Addendum #1

Project Name: Indiana State University – Dreiser Hall Renovation

Project #: 19052

Date: June 12, 2020

1 Floor Plan
Roof Plan
A1.05 1/8" = 1'-0"

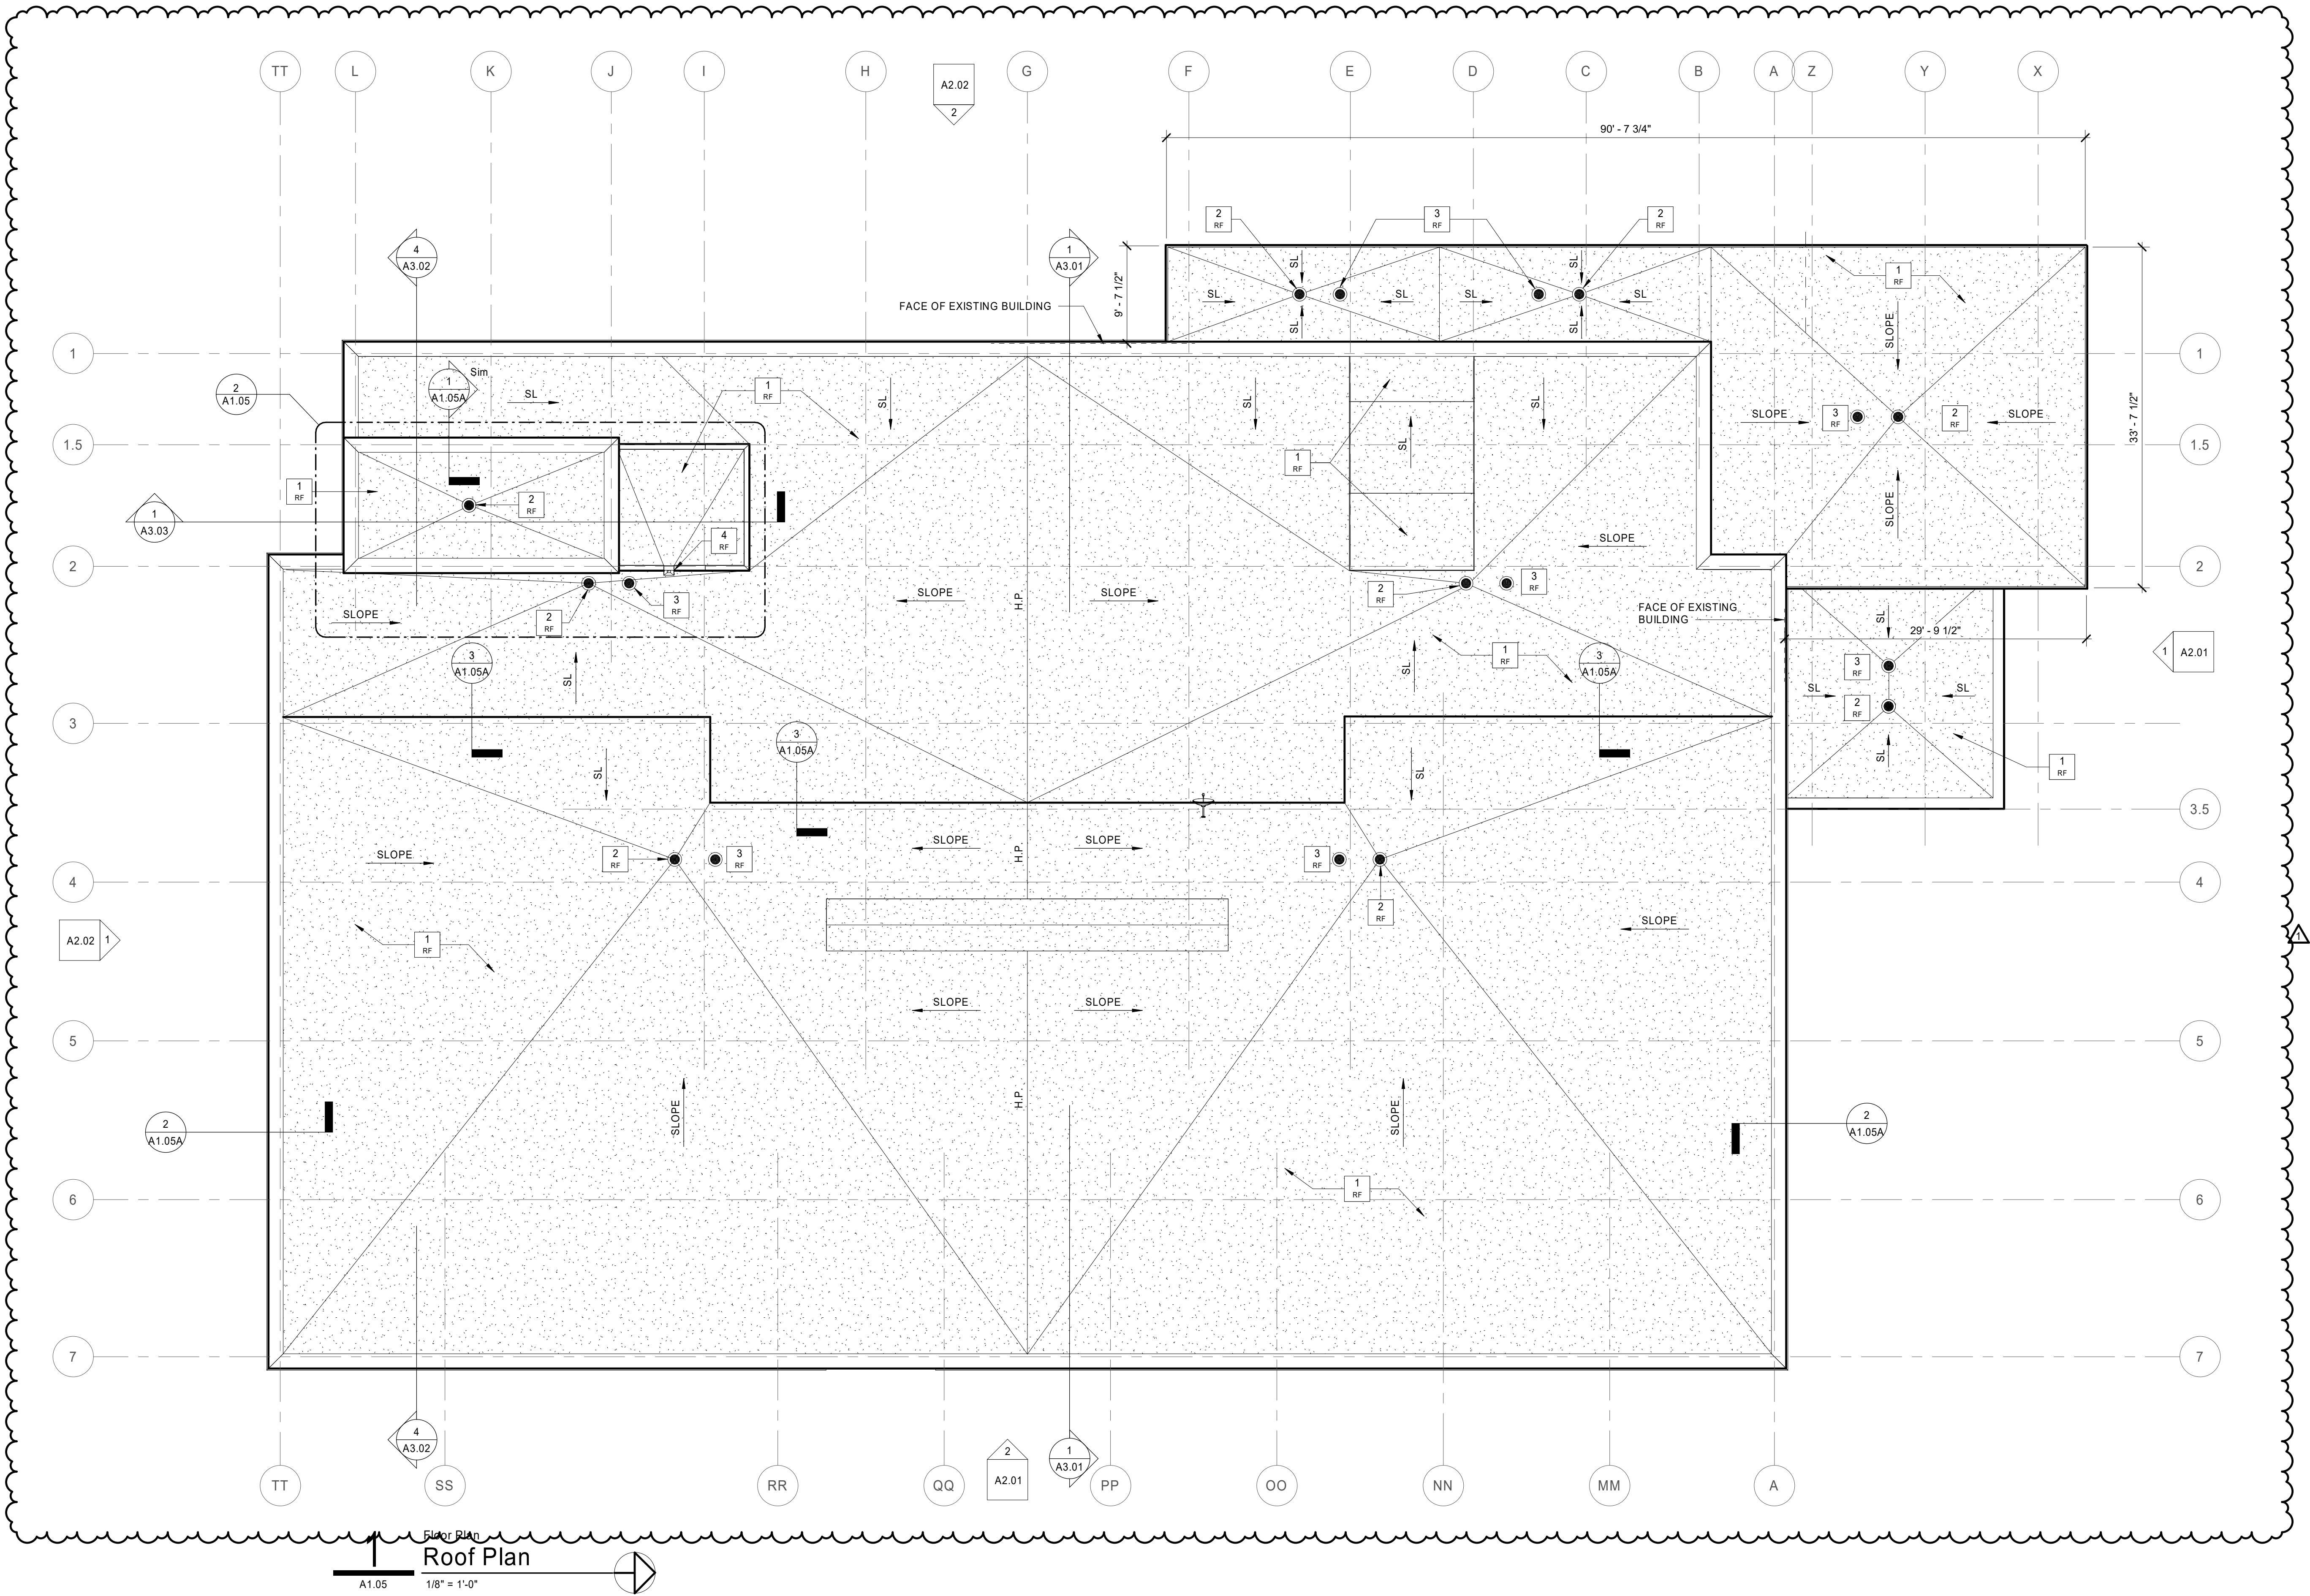
21. A1.05 - Roof Plans

- A. Reissue sheet – see clouds
- B. Added Roof Slope Indications
- C. Revised Coded Notes

4 Wall Section
Window Sill at Addition

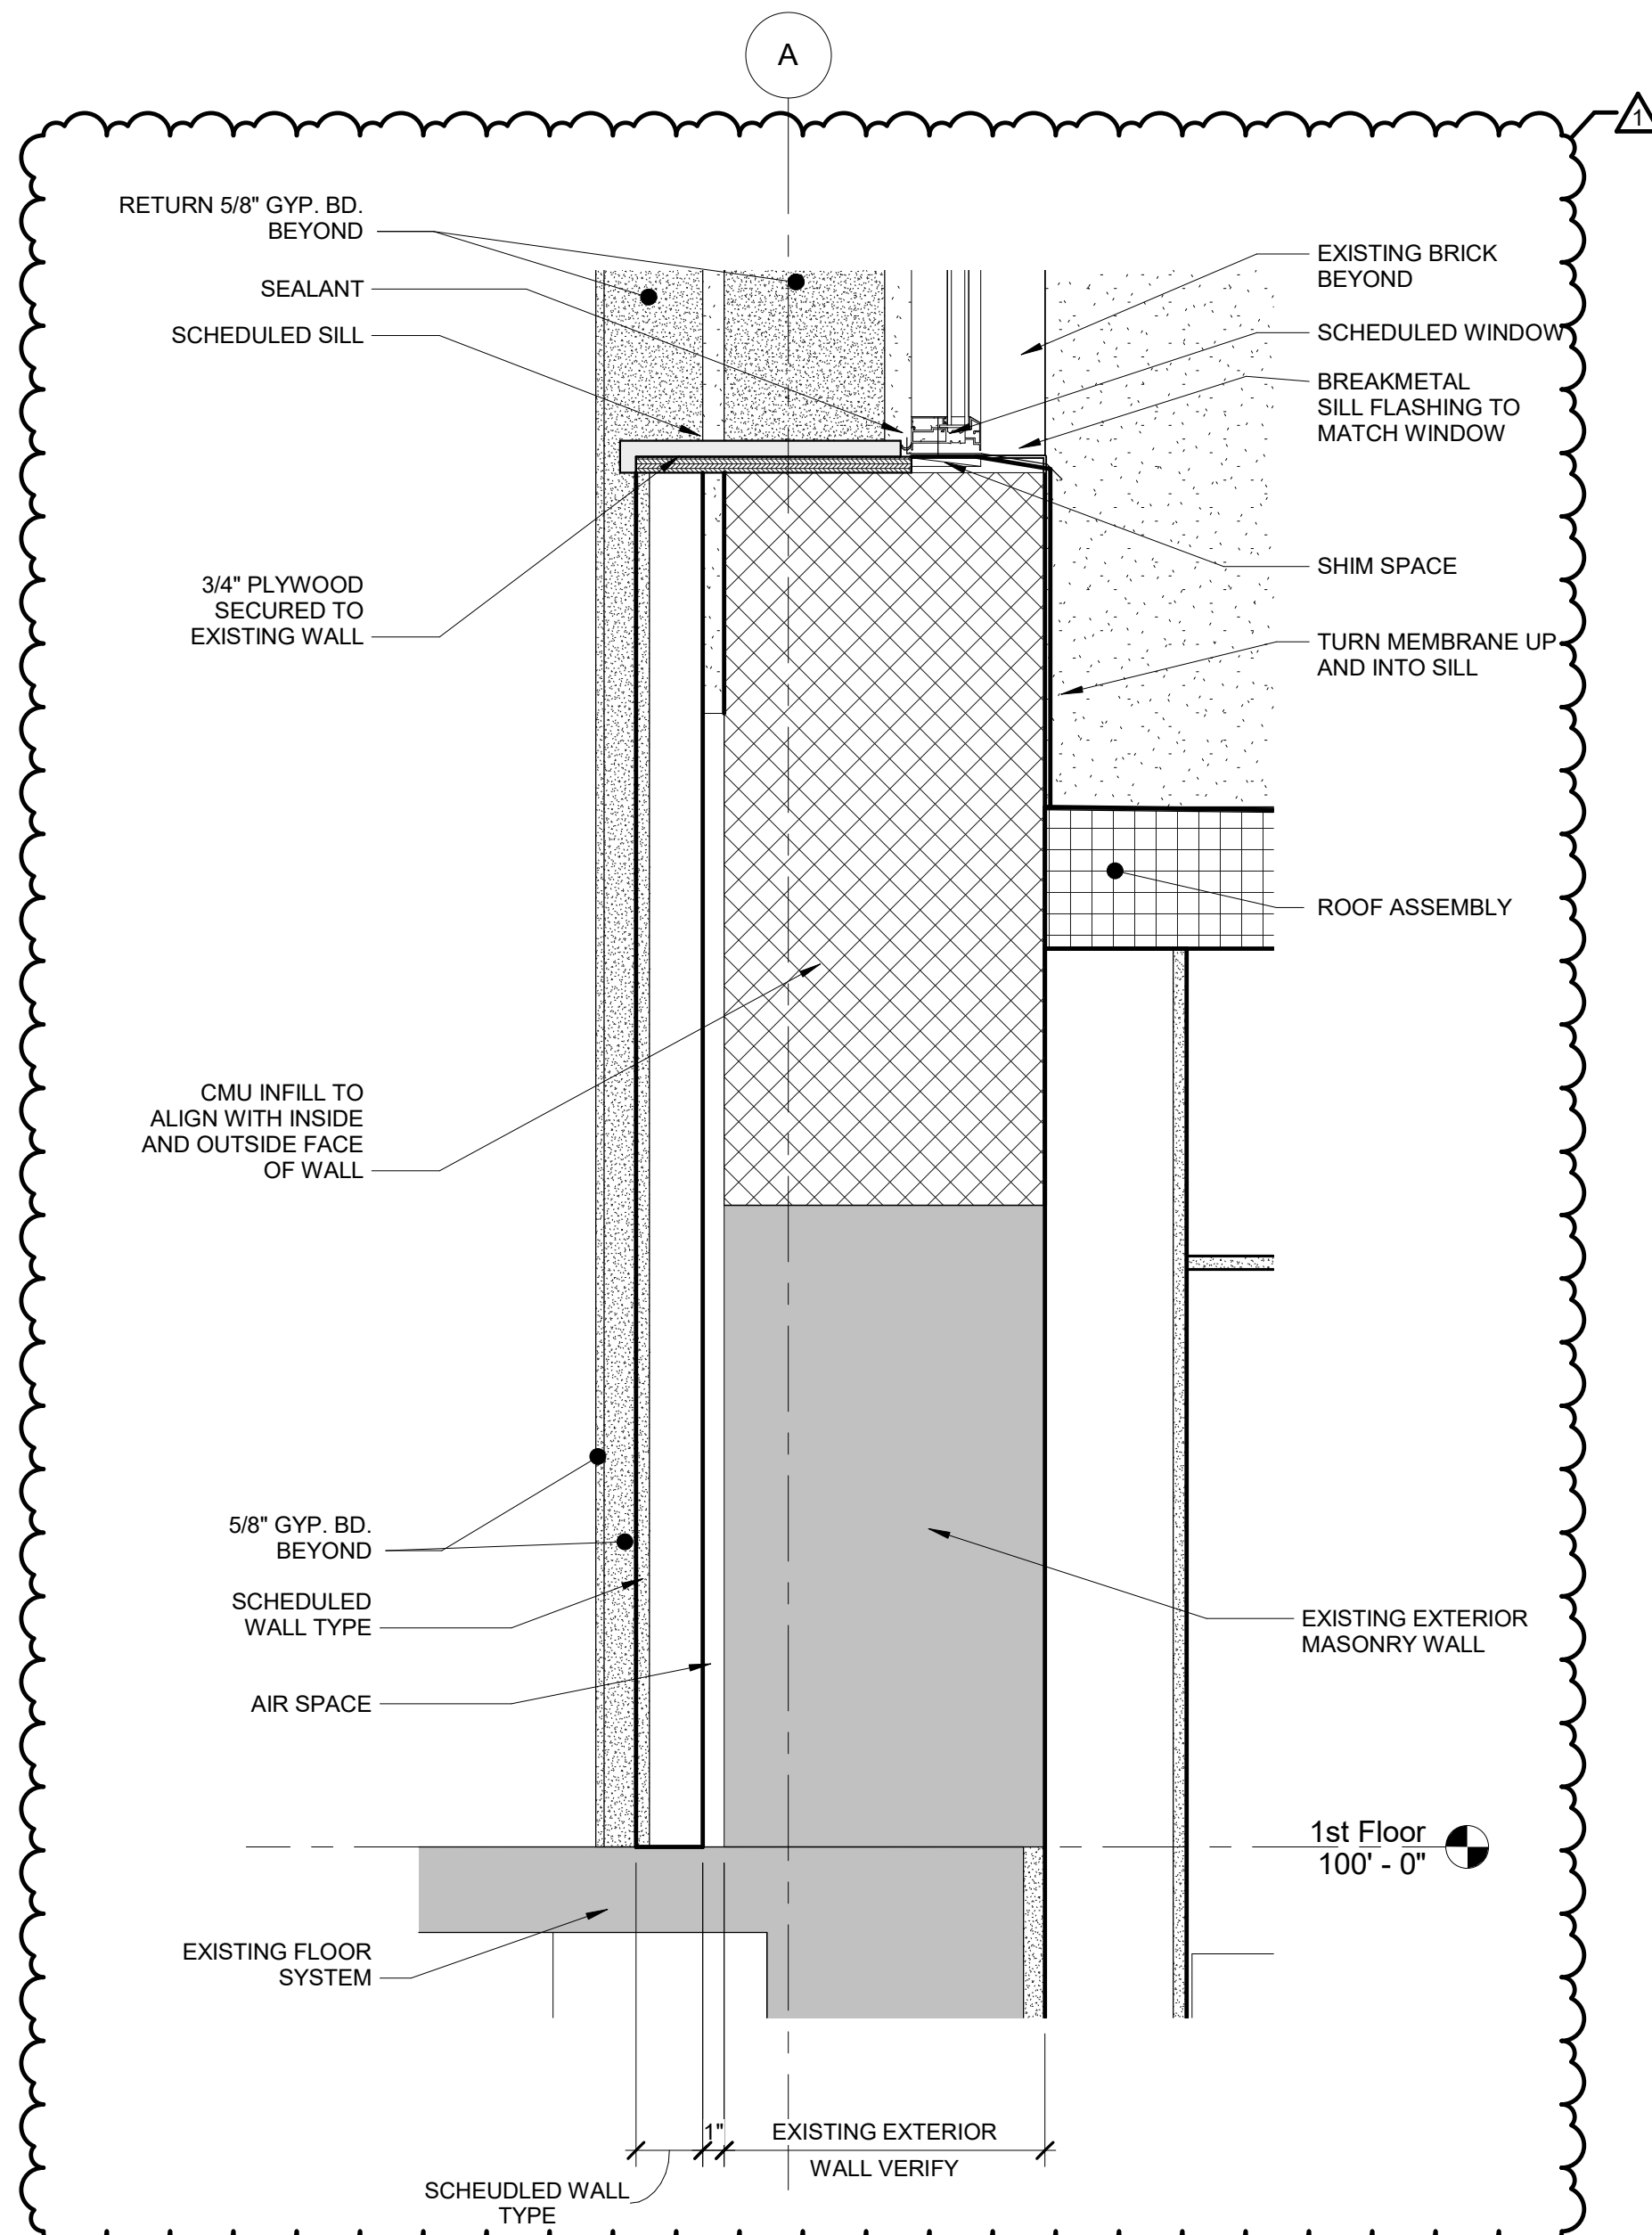
38. Sheet A8.03 – Window Elevations and Details

- A. Reissue sheet – see clouds
- B. Revise Detail 4
- C. Revise Window elevations

Ext Storefront 30 (N Elev)

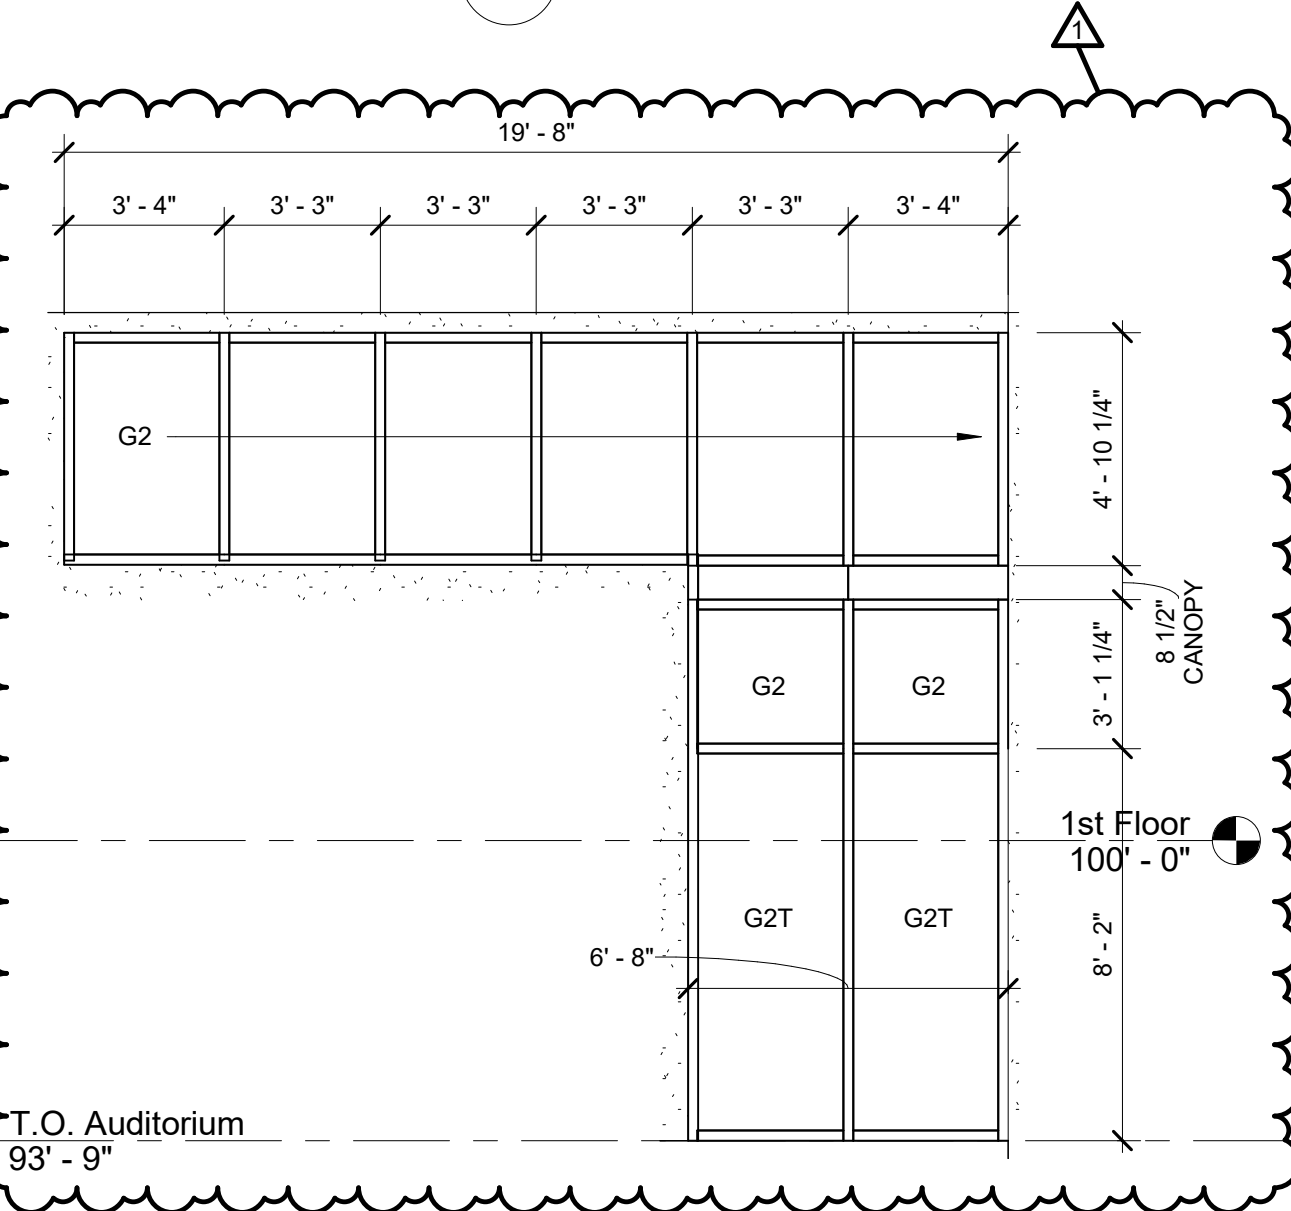
39. Sheet A8.20 – Exterior Storefront Elevations and Frames

- A. Reissue sheet – see clouds
- B. Revise General Notes
- C. Revise storefront/curtainwall elevation W30 and W37
- D. Revise and add details related to interior storefront applications.
